07BLD-00000-00156

237 CARACARA LN, COMO, CO 80432

RESIDENTIAL INSPECTION
FOR
PAUL HENDRICKS
4001 S. ELATI
ENGLEWOOD, COLORADO

RE: YOUR HOUSE PROJECT IN PARK COUNTY
237 Caracara Lane, lot 213 Elk Horn Ranch filling, Park County, Co. 80440

11. TRUSS JOINTS - BOTTOM CHORD

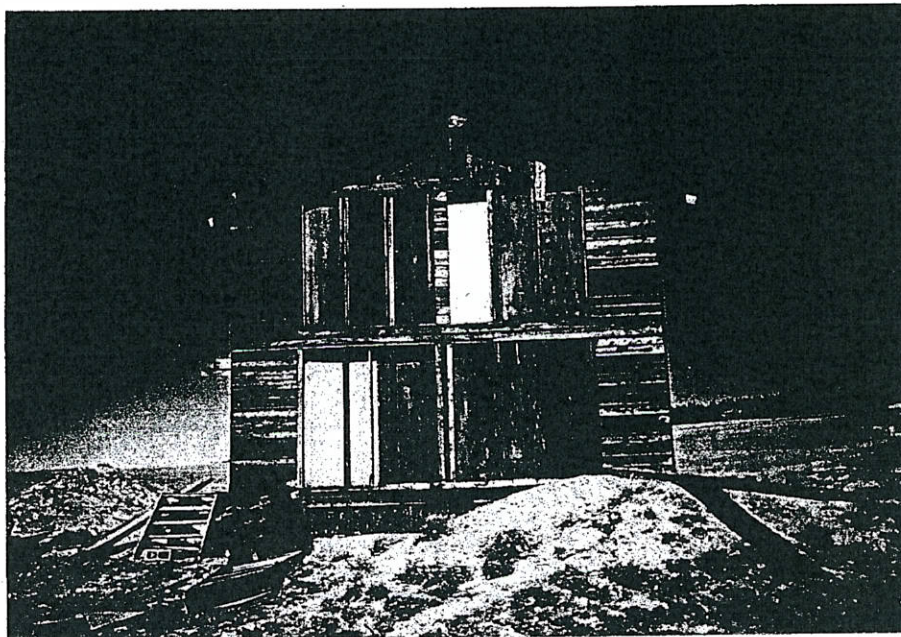
- double 3/4" plywood plate: glued and nailed (30 - #8 nails/joint)
- truss anchors used at all bearing plates over existing exterior walls
- no sign of movement or truss deterioration

13. NORTH ELEVATION

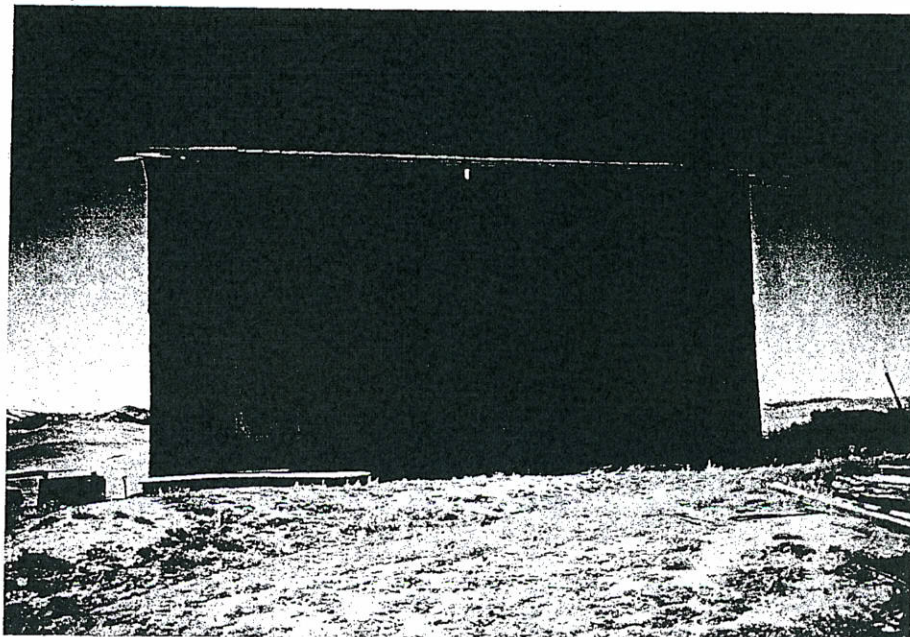
- 1" cedar siding: all rotten or severely weathered materials to be replaced

14. EAST ELEVATION

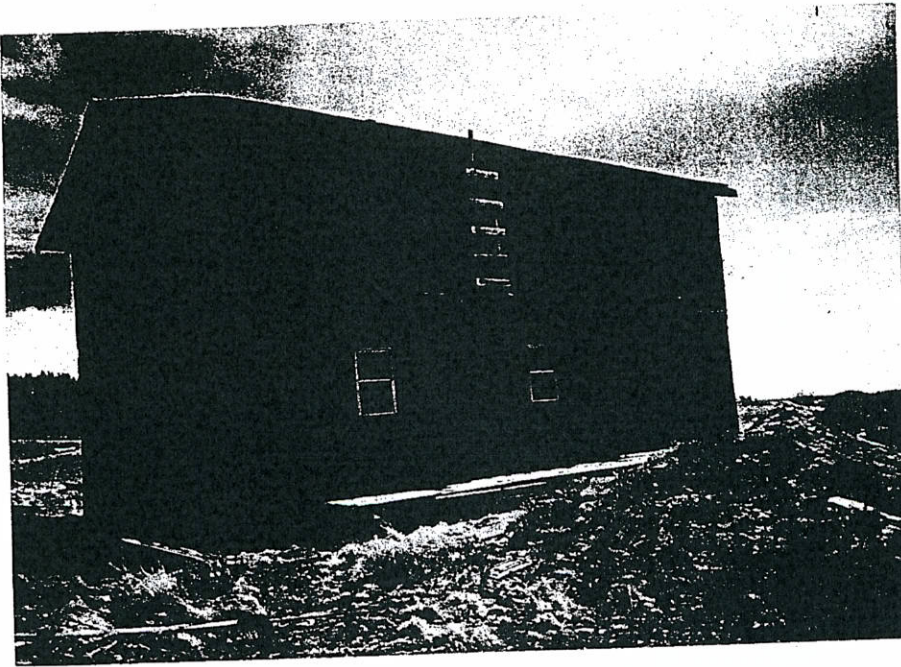
- Masonite siding - all weathered materials to be replaced
- cantilevered deck to be removed and replaced with concrete landing and stairway

15. WEST ELEVATION

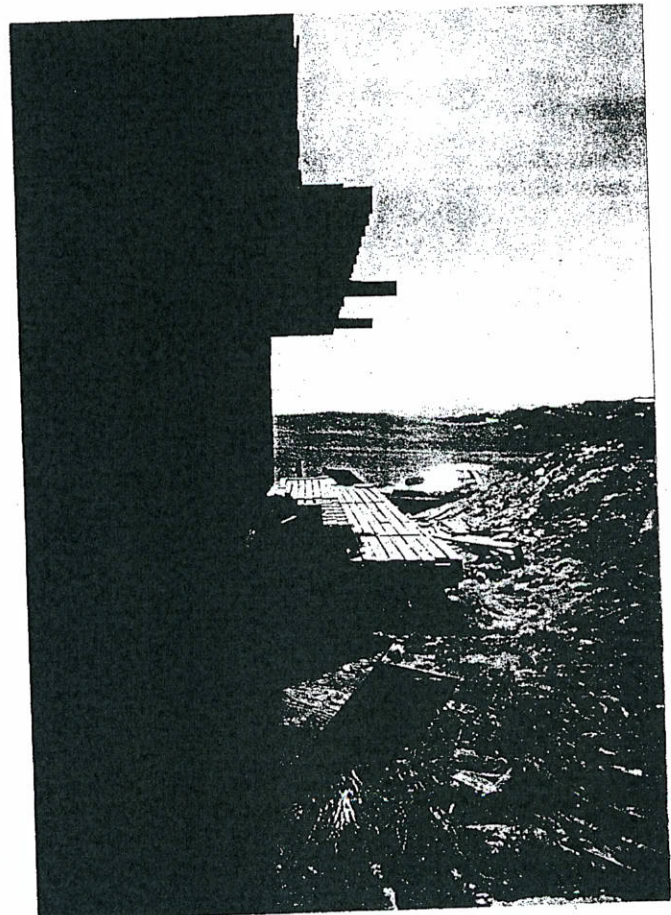
- Masonite siding - all weathered materials to be replaced
- remove cantilevered deck at 2nd floor
- remove exterior door
- replace lower cantilevered deck with concrete landing and stairway
